STAFF'S
REQUEST ANALYSIS
AND
RECOMMENDATION

04PR0227

Robert P. Jones
(Railey Hill Offices)

Midlothian Magisterial District
East Line of North Woolridge Road

1 FRONT ELEVATION
SCALE 1/16" = 1'-0"

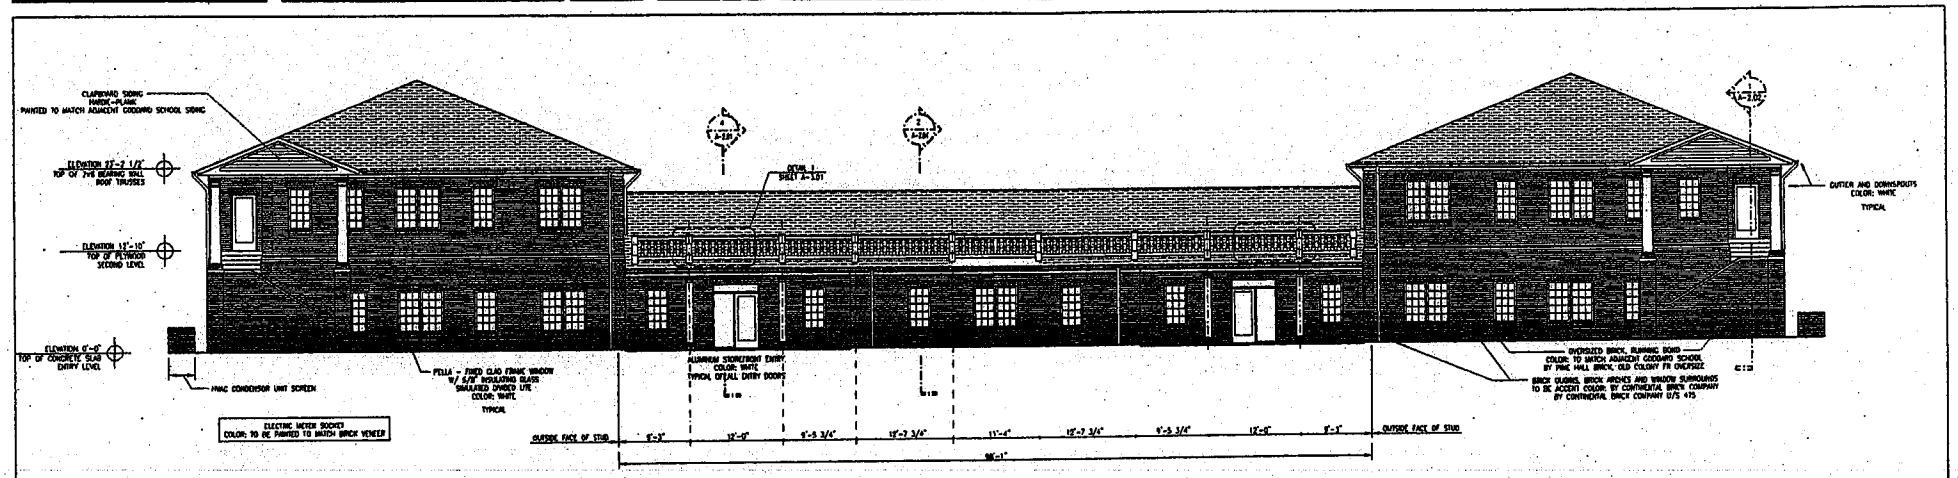
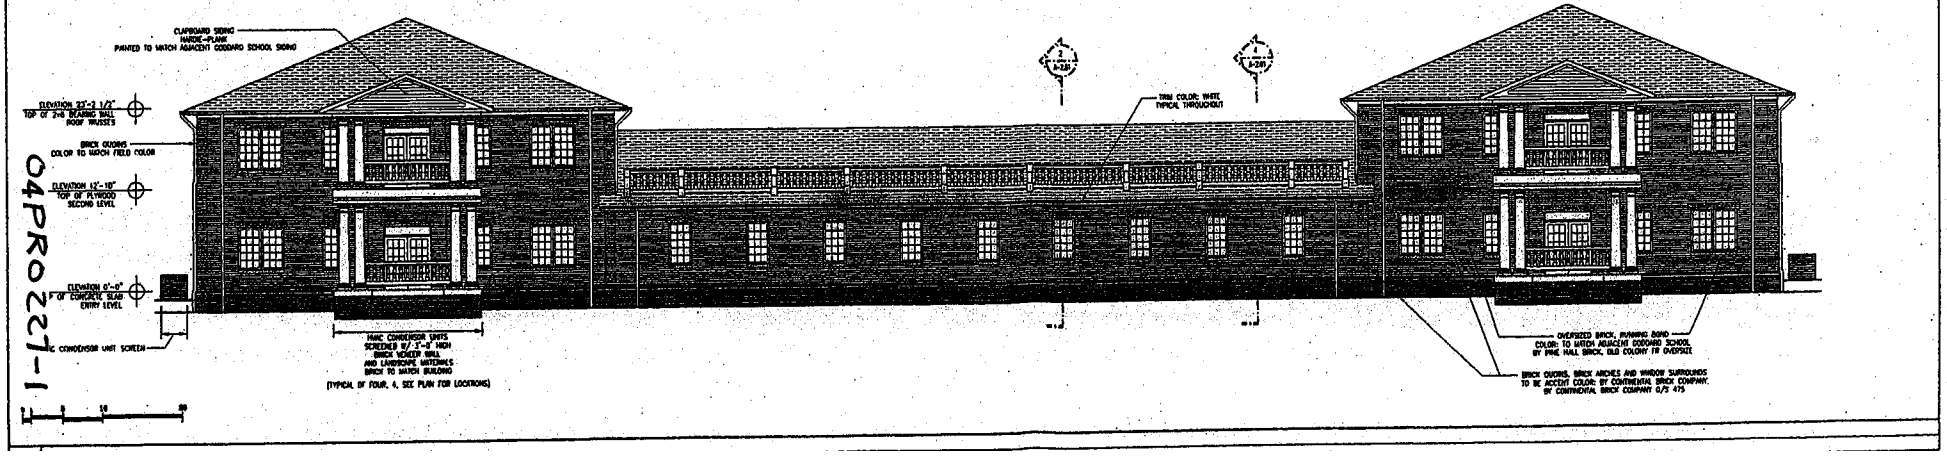
REQUEST: On November 21, 2003, administrative approval was granted to C & G Associates for the Railey Hill Offices site plan Case 03PR0323. Subsequent to this approval, an appeal was filed by Robert P. Jones. Specifically, the appeal addresses ten (10) architectural and landscape design items that includes a request to reverse the design of the structure to have a two (2) story building in the center with one (1) story wing sections. The appeal items also include concerns with the use of a low roof pitch, the choice of materials used for columns, railings and roofing shingles, the lack of chimneys and dormers and the orientation of masonry jack arches that should be vertical and not horizontal. The concern with the landscape design is that insufficient evergreen plantings have been included to anchor the building facing Woolridge Road.

By designing the building as three (3) sections with the two (2) larger end sections, the combined mass of the two (2) story portion is broken in half. The addition of columns, porches and entrance style doors in the center of each two (2) story section provides detail and interest and helps to break up the long facade. The center section is long with a low pitch roof that is not appropriate for dormers.

While chimneys could be added, they are not a requirement. Walgreens does not include chimneys.

As to the masonry jack arches, the brick is designed to be vertical over the windows, thus no change is needed.

The material to be used for the columns, railings and balustrade are not specified on the elevations. In order to provide durable architectural features, suitable materials need to be used. For some of these features, natural material may not be the best choice for either durability or appearance. Although wood is acceptable to staff, other products that may include resins or plastic, such as PVC, may be a better choice. Use of these materials is compatible with materials used at Walgreens and Amoco (now BP), as required by Proffered Condition 12 of zoning Case 99SN0224.

As to the use of metal or wood railings in place of the masonry wall, staff believes that either solution is acceptable architecturally. The roof will be dimensional shingles, as required, in order to match Walgreens, thus no change is needed.
